Unionville Village Architectural Design Review Committee

August 27th , 2015
Conference Room Town Hall

Former McGillicuddys (corner of South Main / New Britain Ave. –

Fencing and pilars for outdoor dining area:

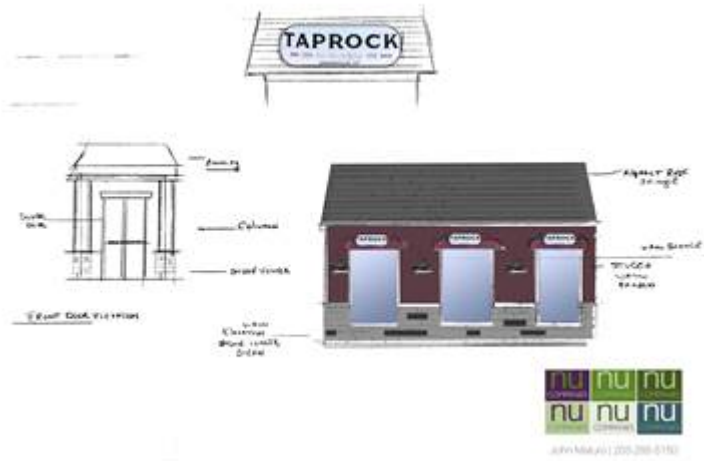
Committee requires that fencing be removable. Fencing and furniture will be removed after October 31st for entire winter until March 31st.
